ACRS-1693

MINUTES OF THE
ACRS SUBCOMMITTEE MEETING ON
FLUID DYNAMICS
NOVEMBER 16, 1979
SAN FRANCISCO, CALIFORNIA

MARK I LONG-TERM PROGRAM STATUS - MR. GRIMES, NRC STAFF

IMPACT TRANSIENT / STEADY DRAG FOR CYLINDER

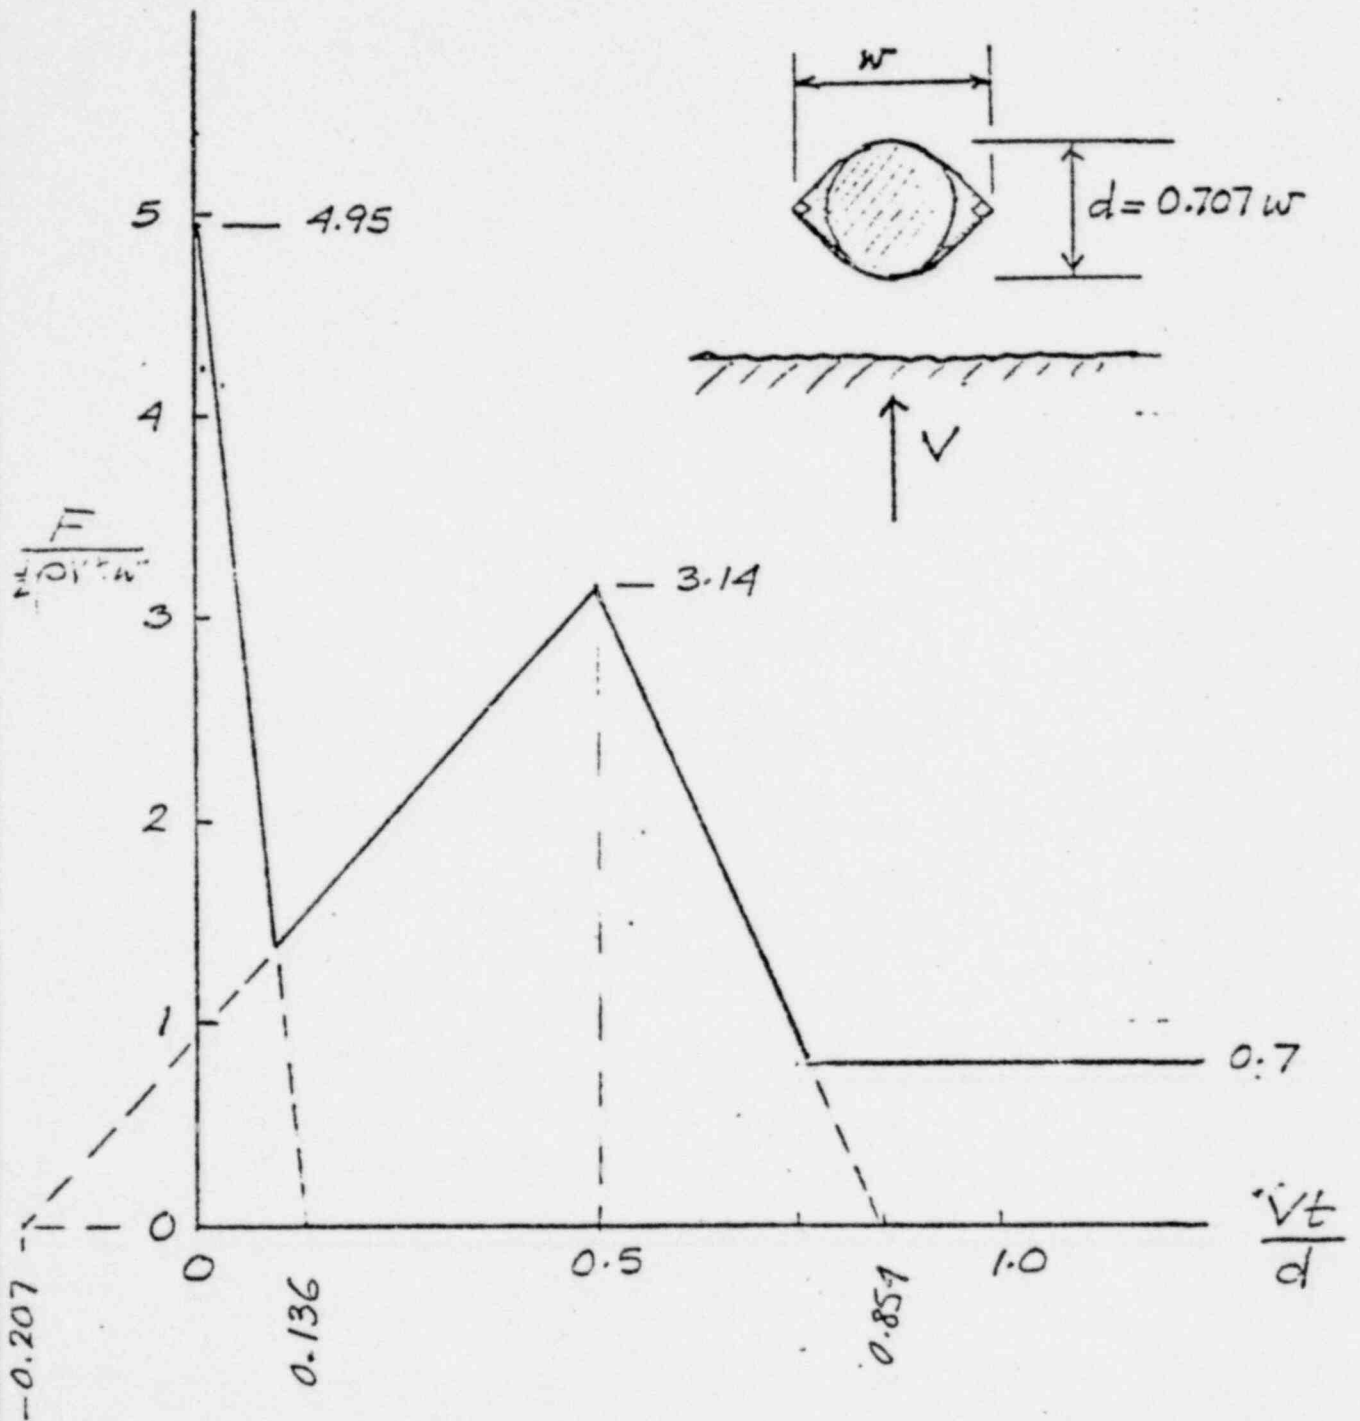
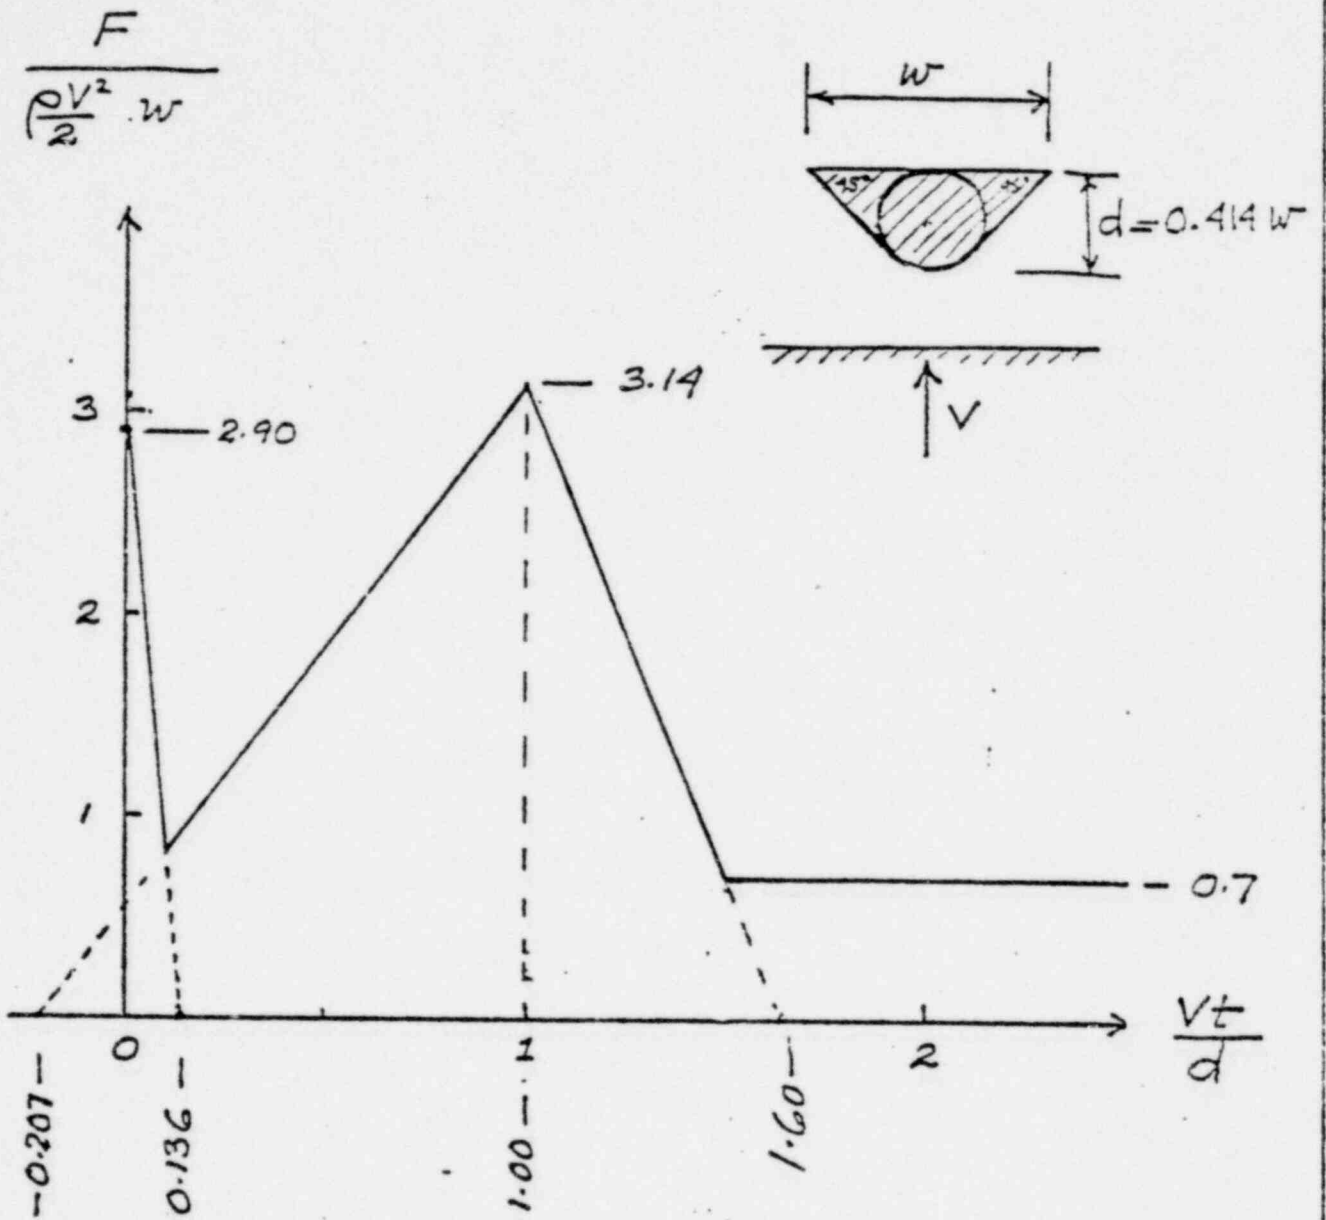
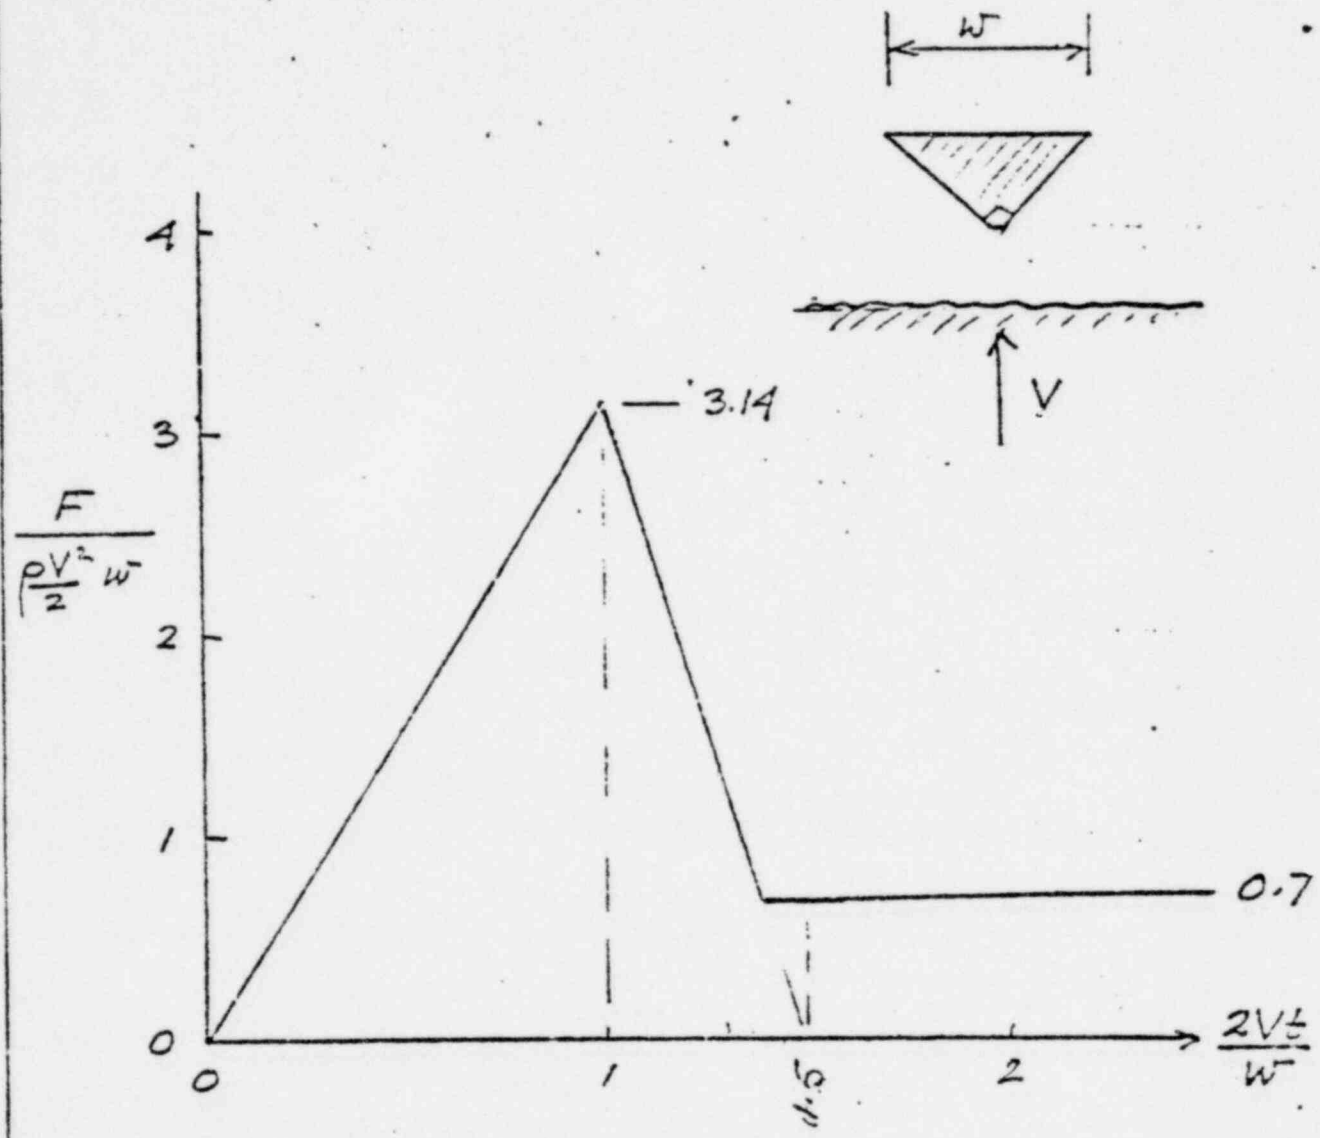
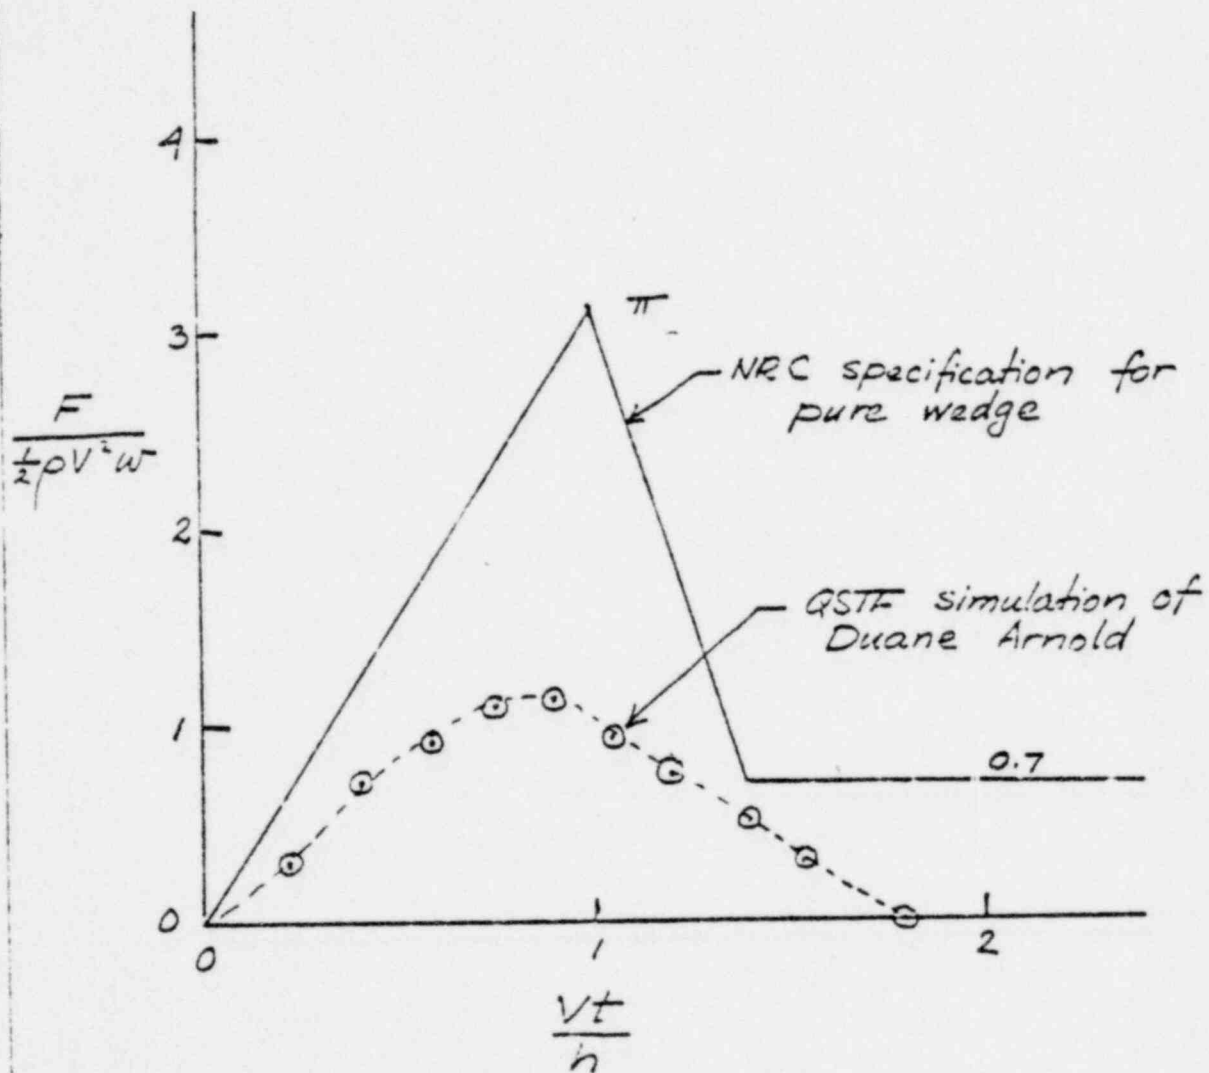
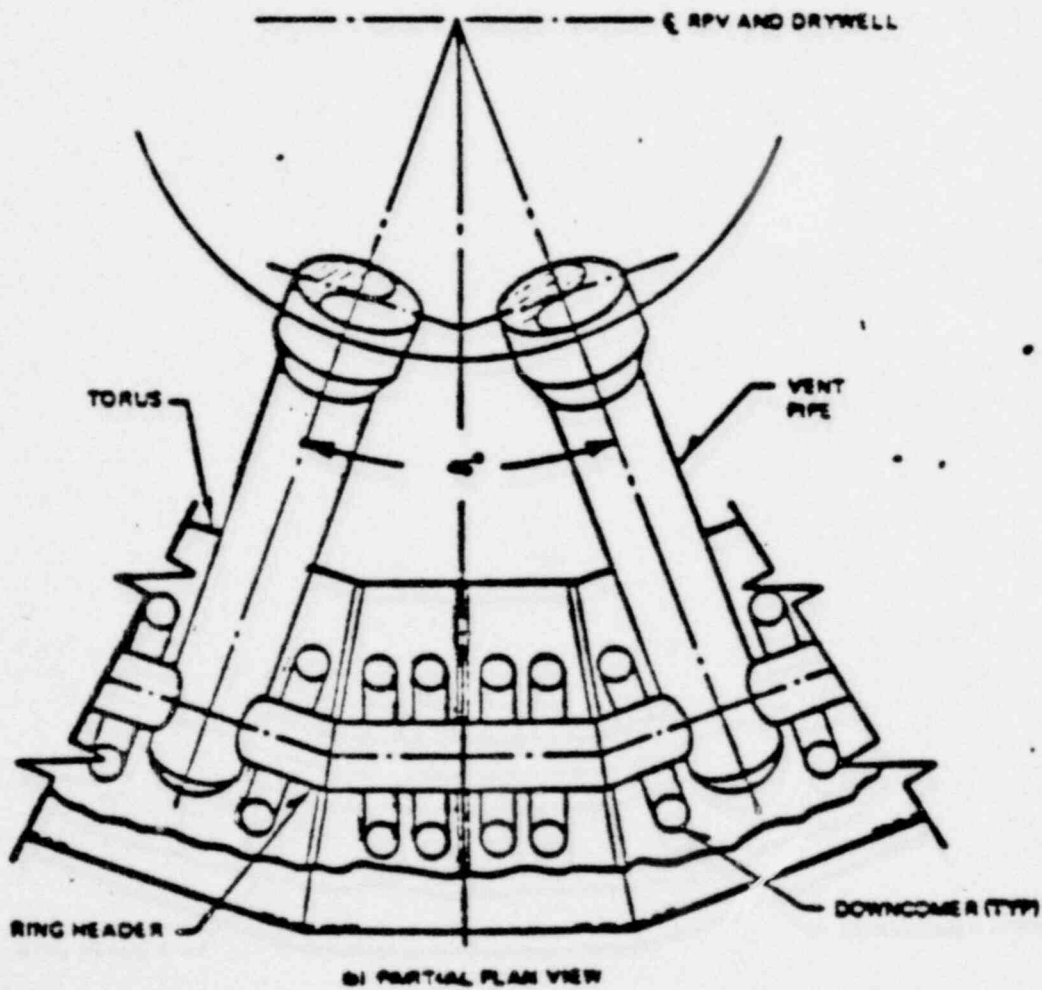
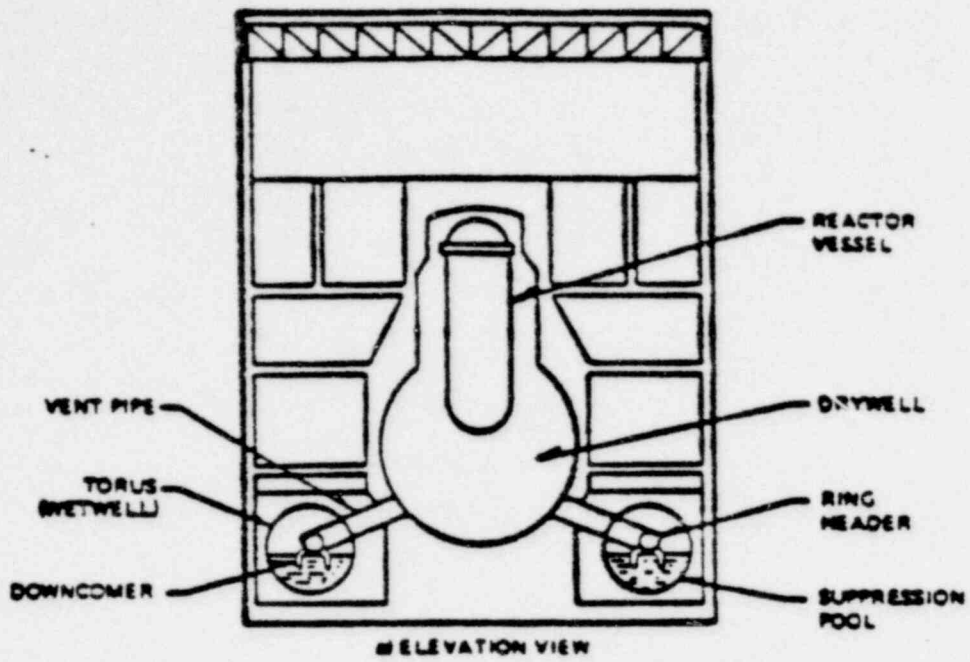
Based on the review of this methodology, the NRC Staff believes that the steady drag coefficient used to compute the cylindrical type deflector loads are non-conservative. They also believe that an appropriate force transient for the wedge-type deflectors has not been specified. Unless all the components associated with this methodology are conservatively defined, the NRC Staff believes that this approach may not provide acceptable deflector loads. Therefore, the NRC Staff requires that the steady drag coefficient used in this

Dr. Sonin discussed briefly the NRC Staff's definitions for the impact transients and steady drag coefficient (Attachment F, pages 9-13) and stated that the NRC Staff believes that use of these values in the Mark I Owners Group semi-empirical methodology may produce conservative deflector loads.

methodology should be redefined. They also require that, when applying the load to the deflector, the inertia due to the added mass of the water impacting the deflector must be accounted for in the structural assessment.

AMPLIFICATION FACTOR FOR TOTAL VERTICAL FORCE VS FREQUENCY
 ("RIGID" FORCE = "FLEXIBLE" FORCE / AMPLIFICATION FACTOR)

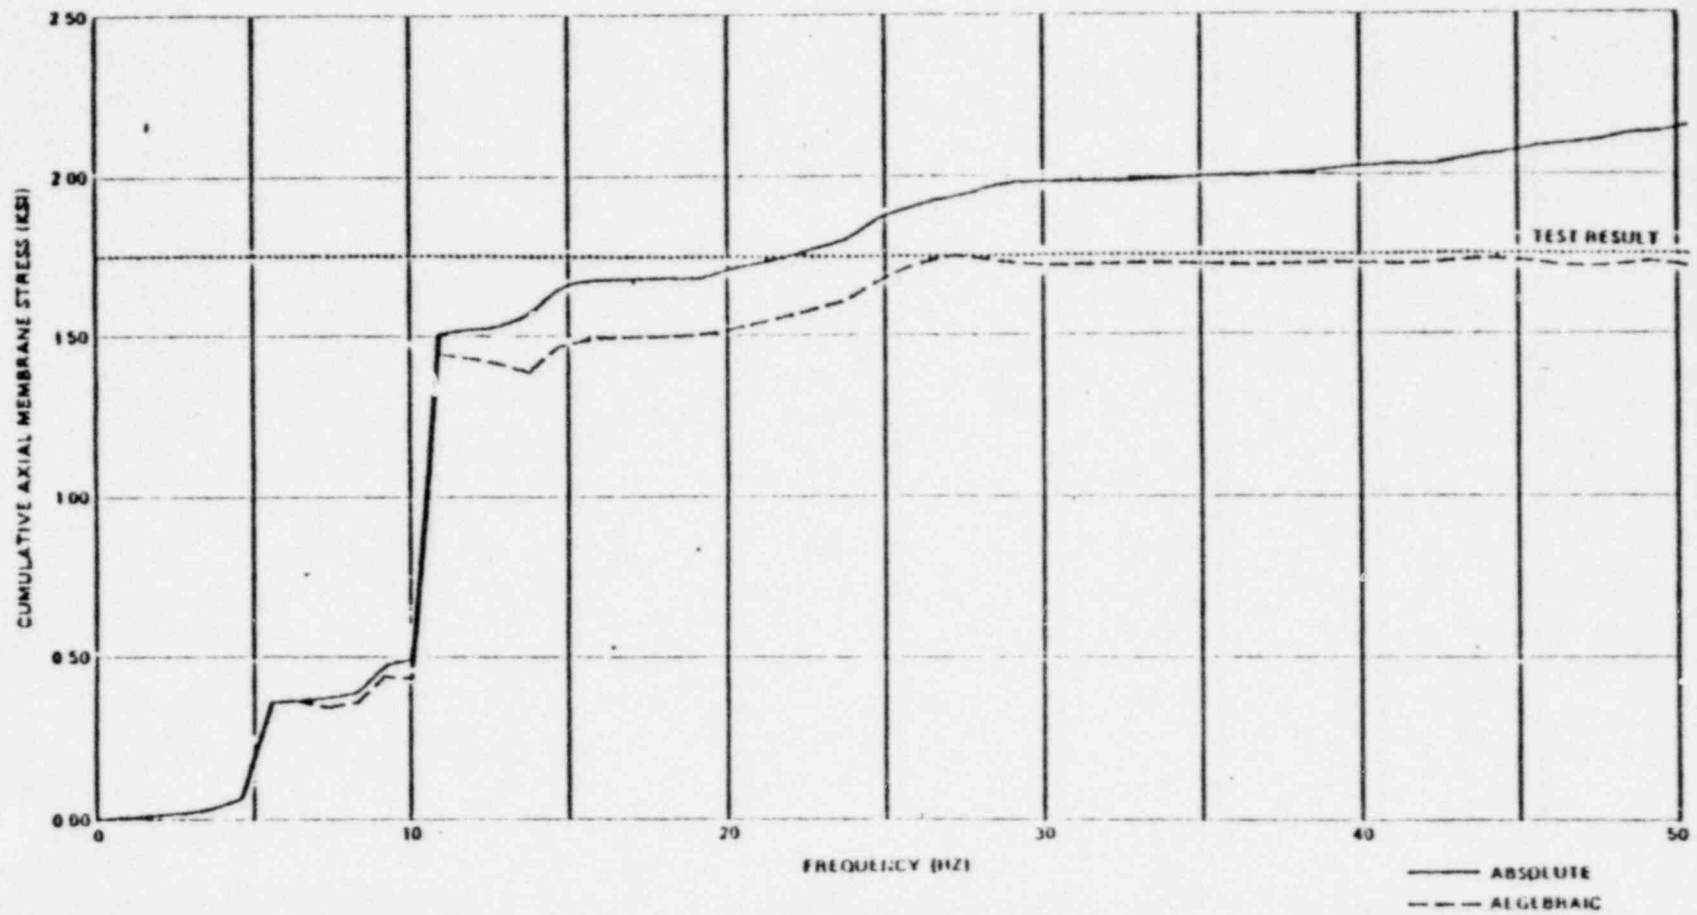
Mr. Broman pointed out that the results of the analysis indicated that the maximum difference between the flexible and rigid wall pressure occur in a frequency range of 16 to 17 Hz (Attachment G, page 13). He indicated that the same type of behavior was also observed during the shake tests.
